Olive Downs Coking Coal Project

Additional Information to the
Environmental Impact Statement

Section 15

**Cumulative Impact Assessment
– Hydrology and Flooding**

Figure 15-1

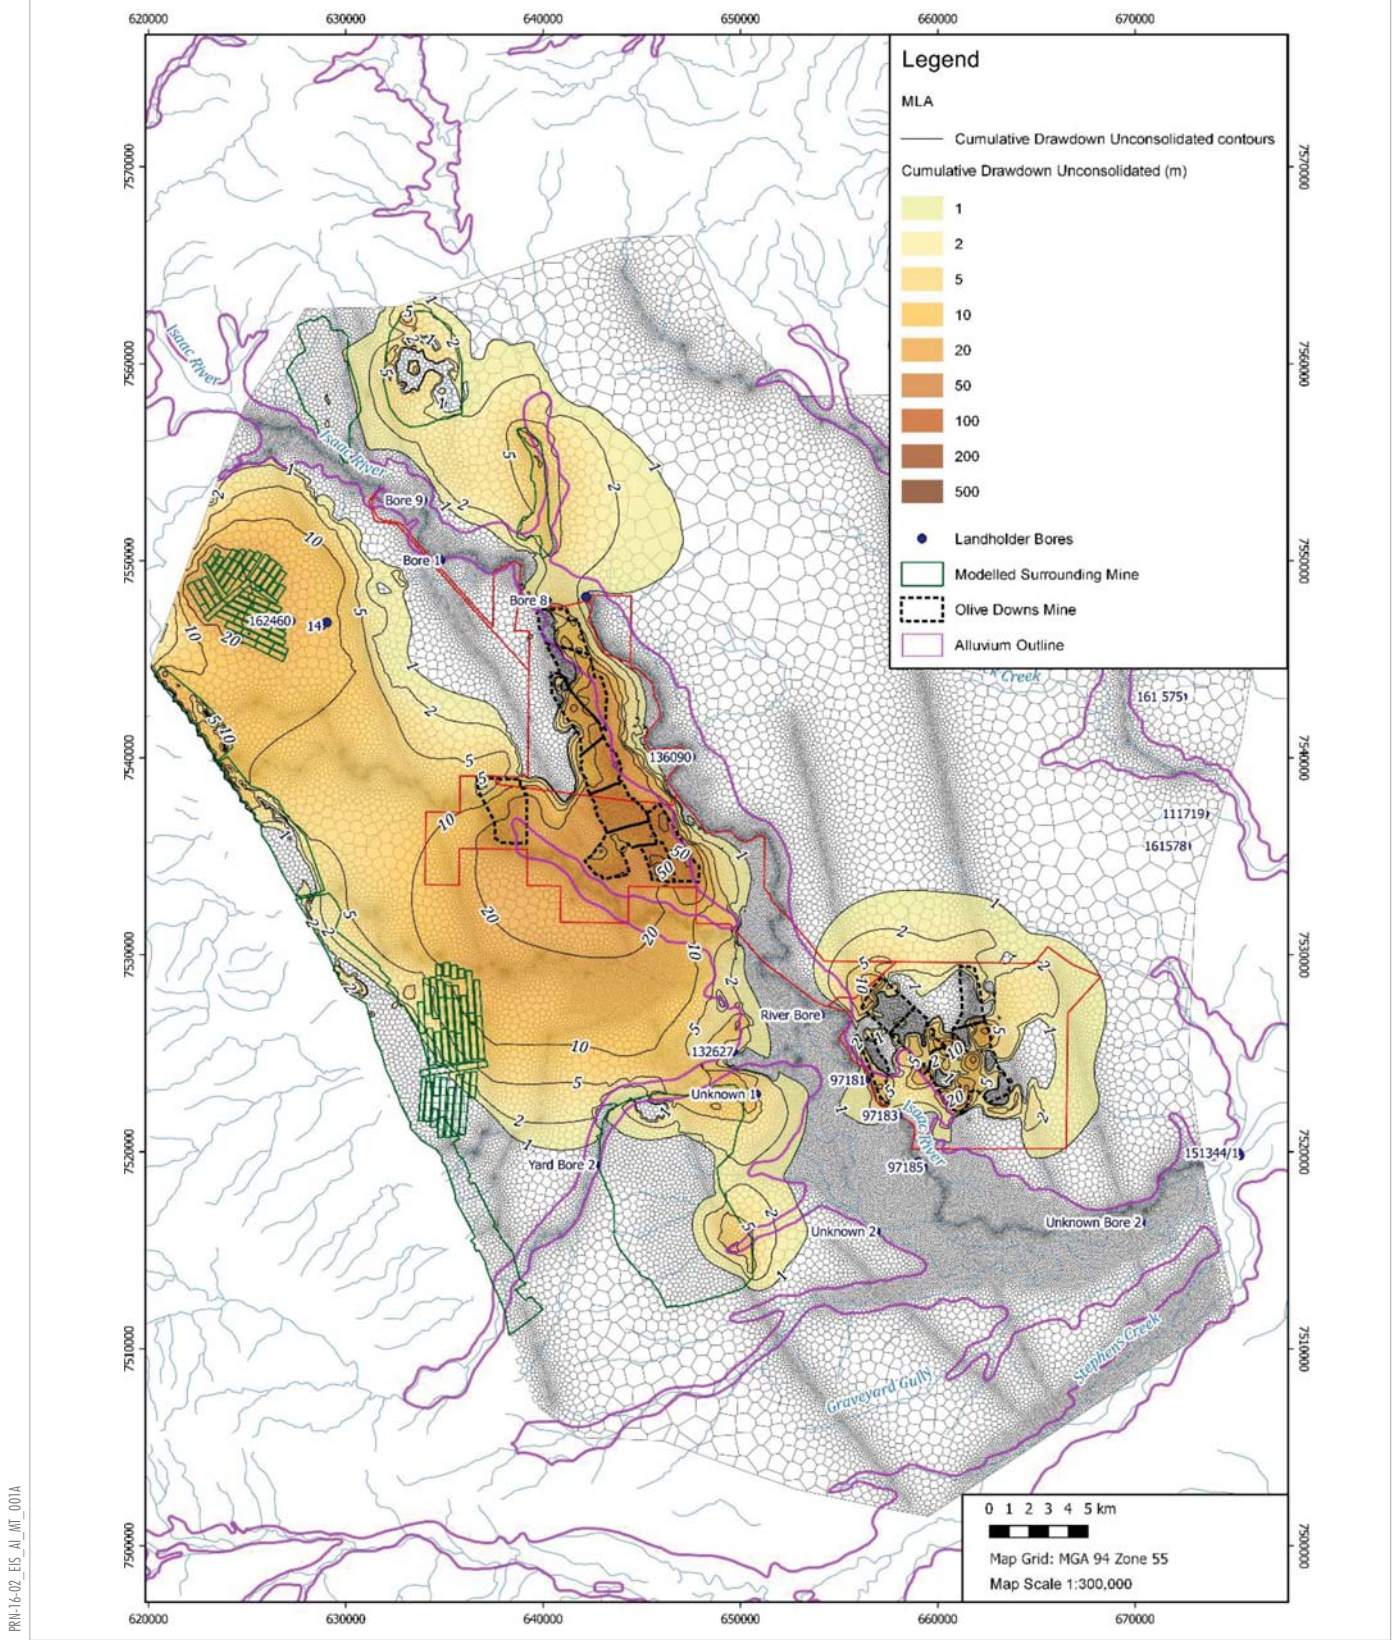
- 1. Further assessment of the cumulative impacts of the project to groundwater and surface water hydrology is required in response to the breadth of issues raised by DES and the IESC. The scope of further cumulative impact assessment is well defined in DES and IESC submissions.**

Figure 6-6 of the Groundwater Assessment (reproduced as Figure 15-1 below) demonstrates the maximum cumulative drawdown within alluvium and regolith (maximum drawdown within saturated extent of layer 1 and layer 2 combined) for the Project. The figure shows the zone of depressurisation from surrounding open cut and underground mines has reached the zone of impact from mining at the Olive Downs South domain. The magnitude of drawdowns is greatest in or closely around the mining area, and gradually reduces with distance from the mine. The zone of depressurisation from the Willunga domain is not affected by mining at surrounding mines.

Modelling of the potential drawdown impacts in the alluvial system along the Isaac River indicates that cumulative drawdown impacts are only predicted at the northern extent of the Olive Downs South domain (Figure 15-1). The cumulative impacts are associated with the Project and the Moorvale South Mine, and are predicted to result in a groundwater drawdown in the Isaac River alluvium of approximately 2 m (or less).

Although the potential cumulative drawdown of approximately 2 m is predicted to occur in the Isaac River riparian corridor (where vegetation may be intermittently dependent on subsurface expression of groundwater), as described in Appendix E of this Additional Information to the EIS, it is unlikely that this potential impact would result in a significant impact to terrestrial riparian vegetation. This is due to the fact that this vegetation is subject to continuous (natural) wetting and drying cycles and these communities are most likely facultative GDEs which rely more heavily on the replenishment of moisture in the soil following rainfall rather than access to the groundwater system. The Project would not result in a drawdown in the alluvial aquifers that would dewater the aquifer to the extent that it would not recover following rainfall (HydroSimulations, pers comm.).

Figure 15-3

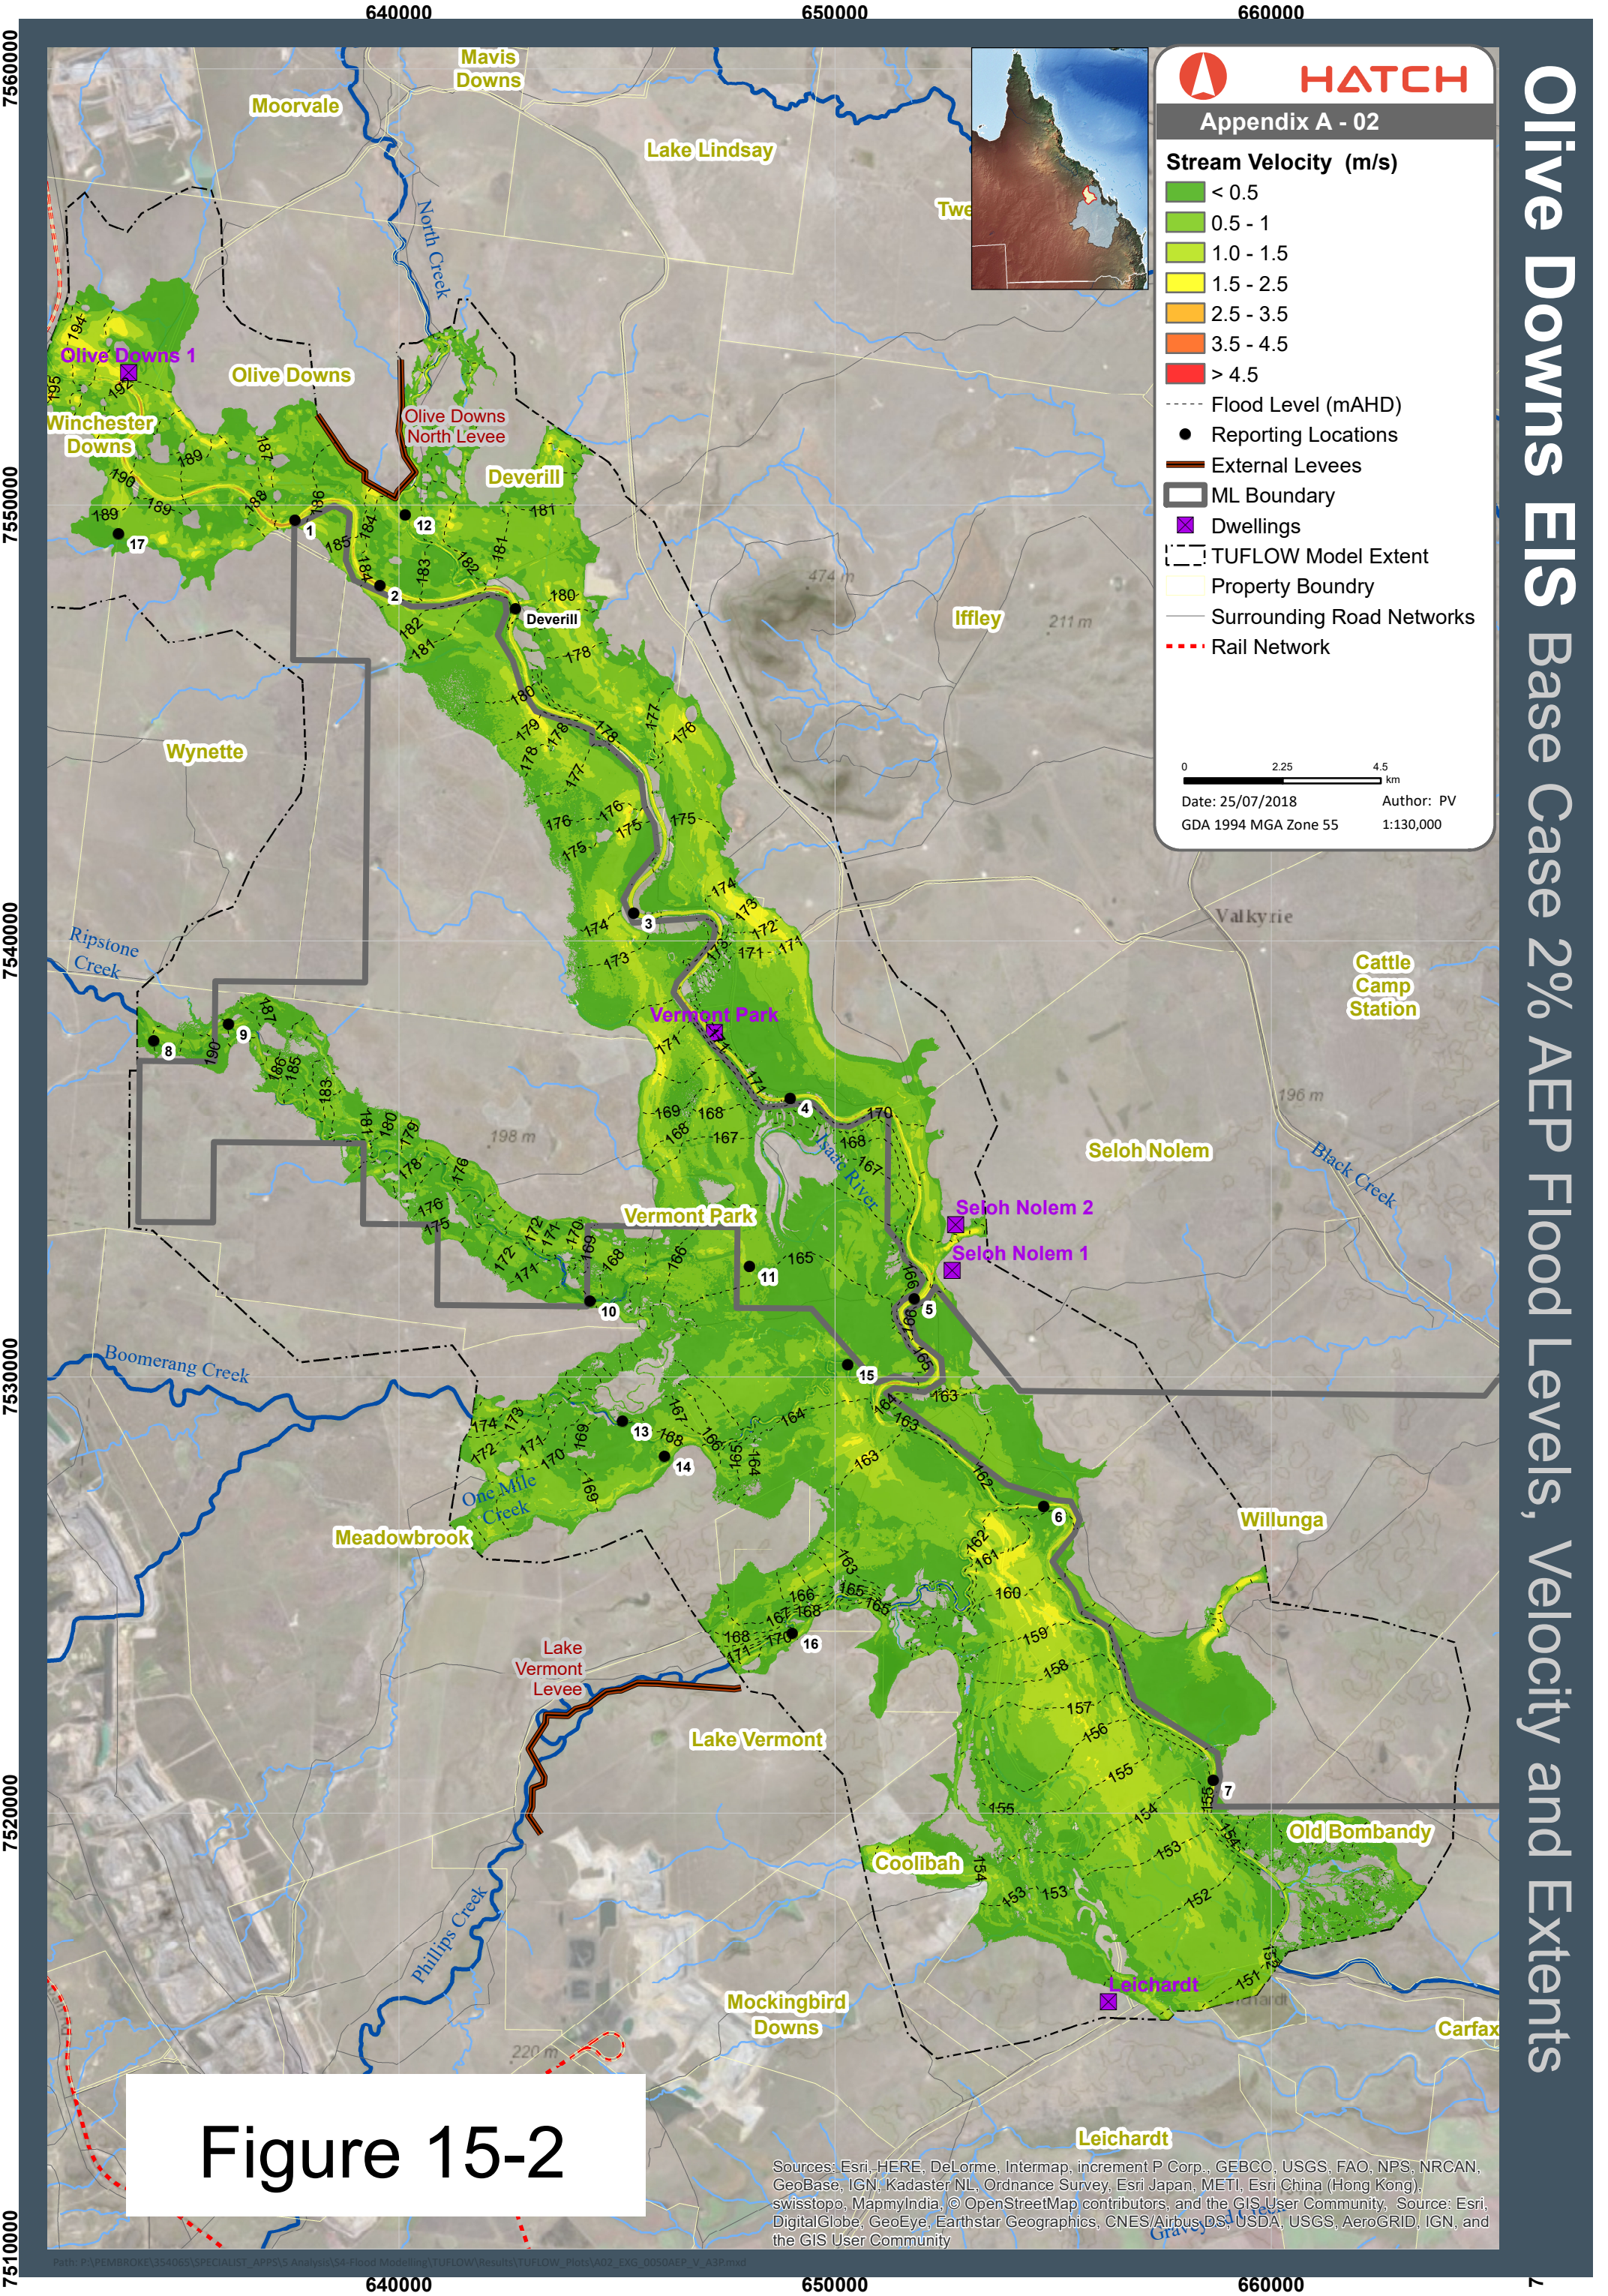
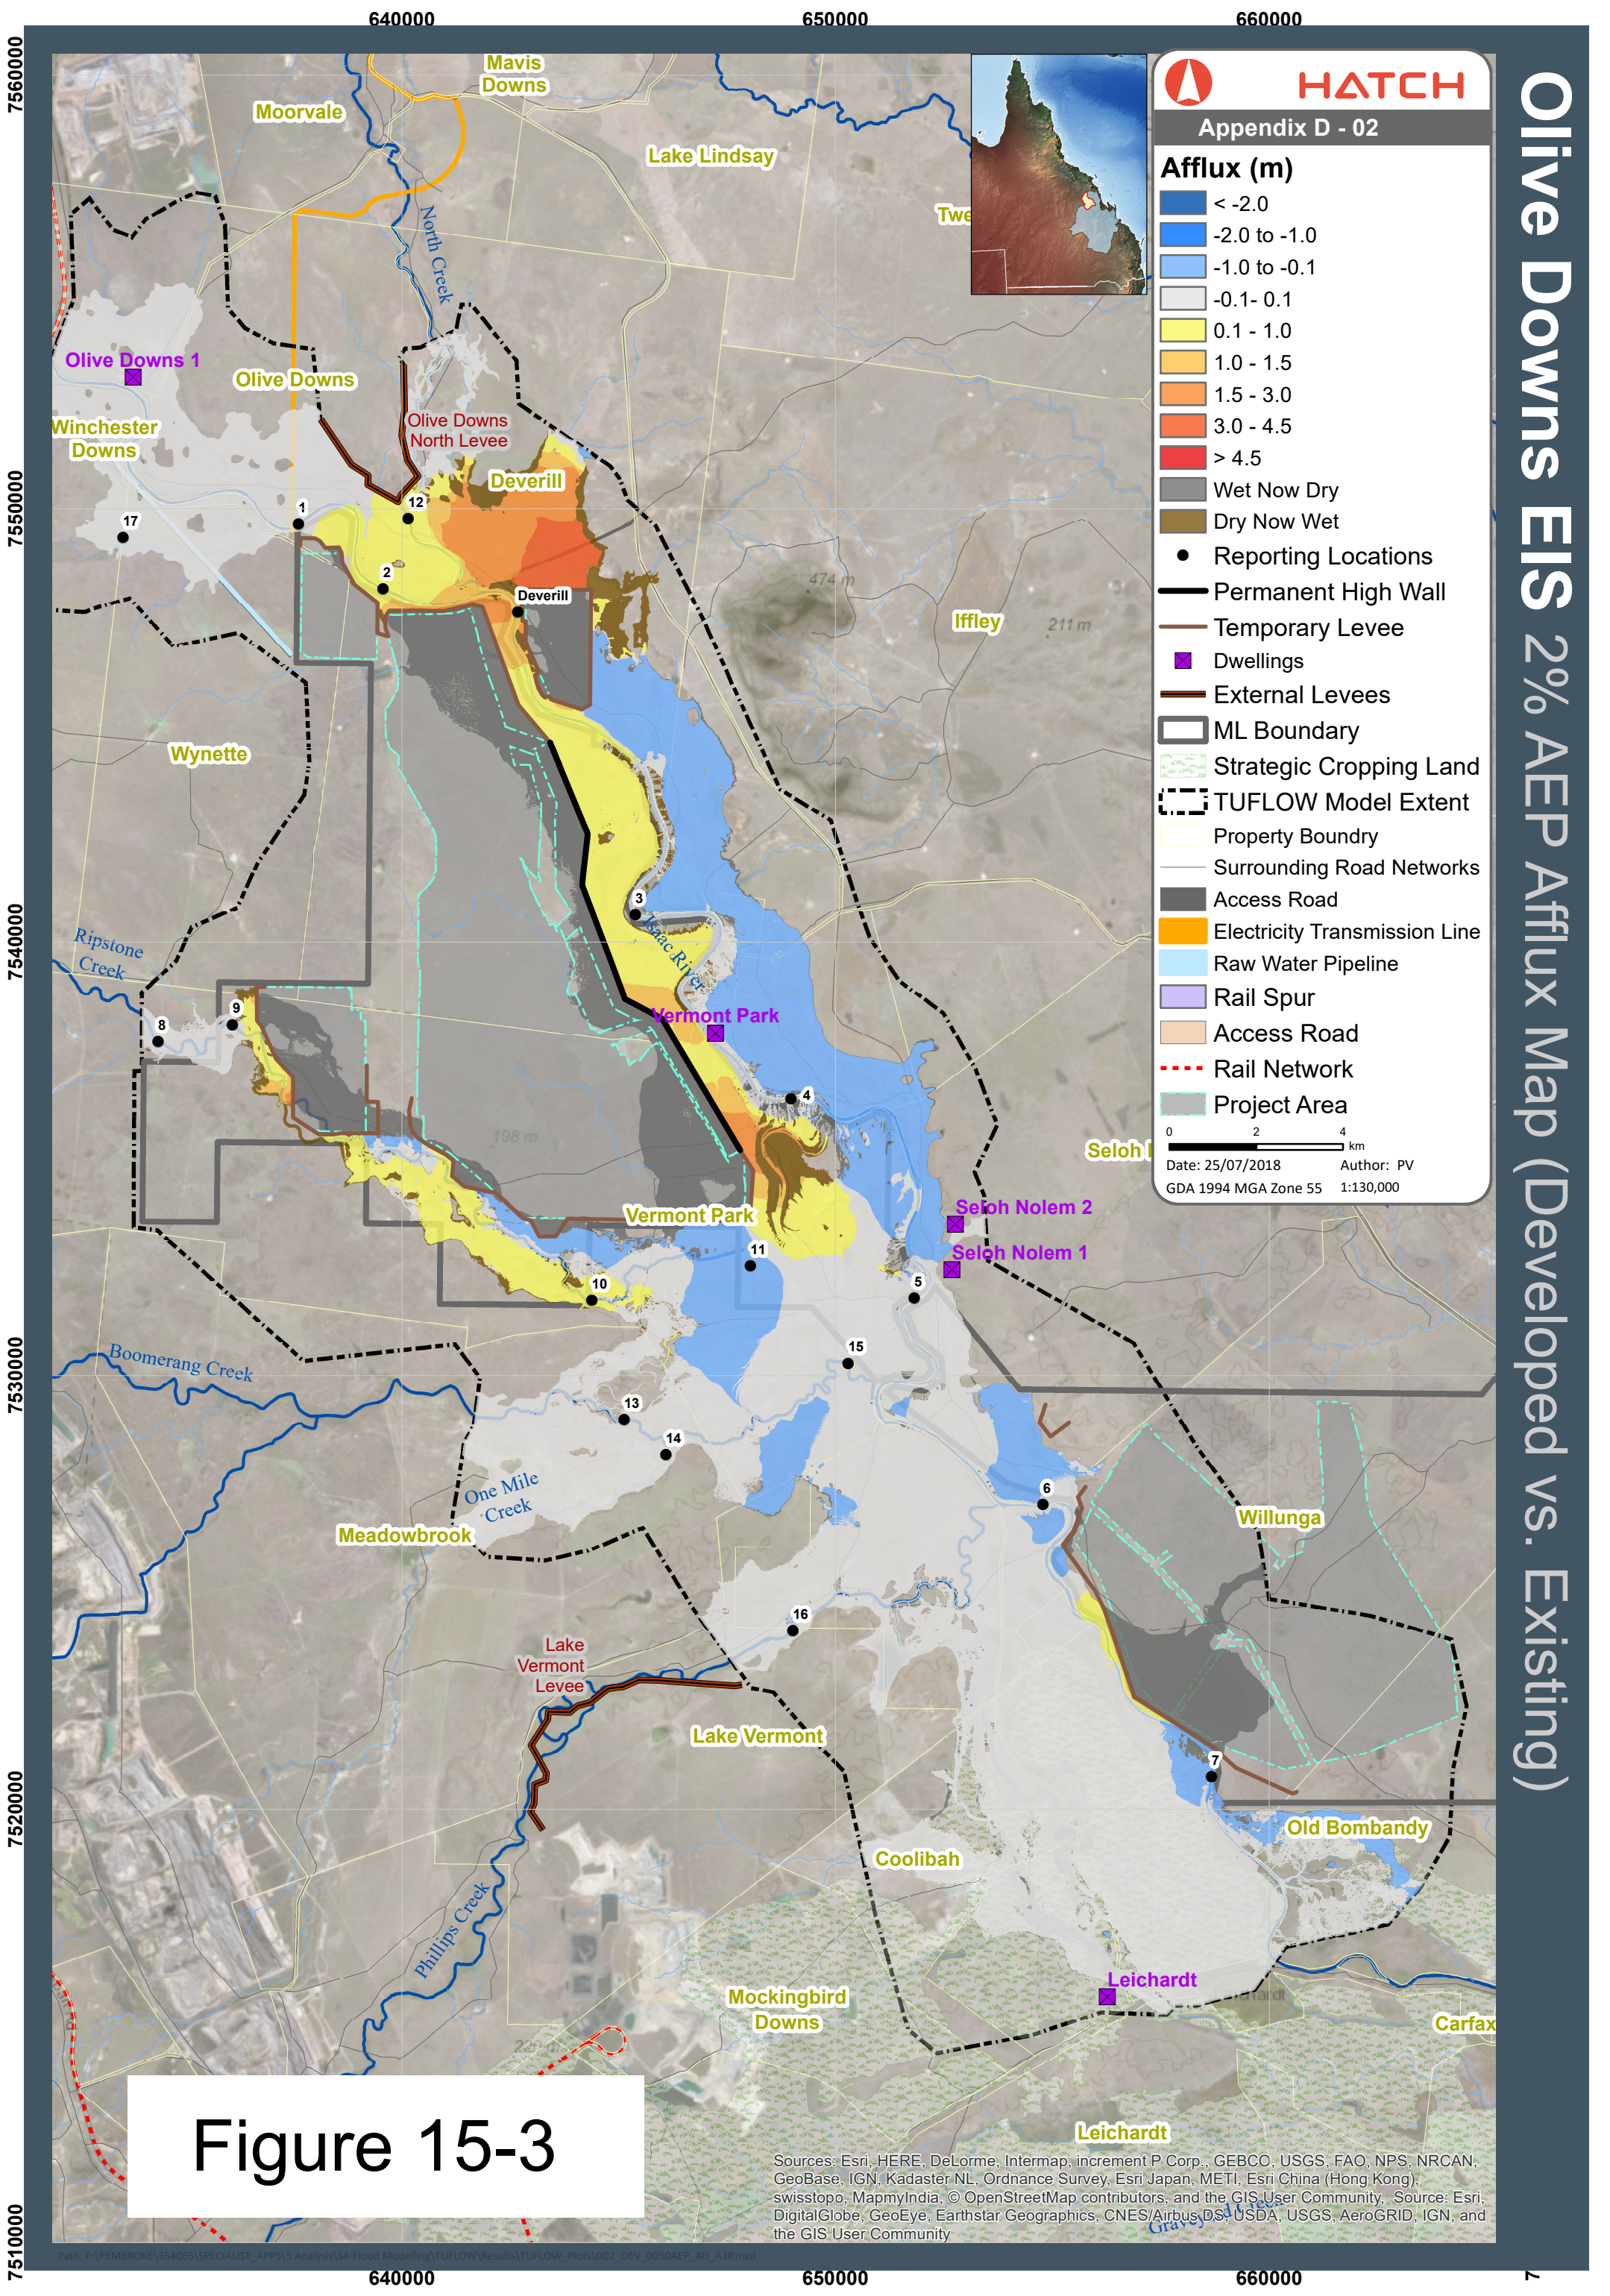
c) An assessment of potential cumulative impacts of mining activities on water resources downstream

The existing flood conditions for a 2% annual exceedance probability flood event (i.e. a 1 in 50-year flood) are shown on Figure 15-2 (extracted from the Flood Assessment [Appendix F of the draft EIS]). Figure 15-3 shows that, with the development of the Project, predicted changes to flood levels are largely expected to be constrained to the Project mining tenements and Pembroke-owned land. Land on the eastern side of the Isaac River is predicted to experience a small decrease in flood levels (due to upstream flood waters being held back by the Project landforms). In particular, Figure 15-3 shows that changes to flood levels during a 1 in 50-year flood at privately-owned dwellings are predicted to be less than 0.1 m. The predicted changes to flood characteristics for other flood events are shown in Appendix D of the Flood Assessment.

As shown on Figure 15-3, changes to flood characteristics are predicted to be negligible within approximately 2 km downstream of the Project. Accordingly, impacts to downstream water resources associated with changes to flood characteristics are predicted to be negligible.
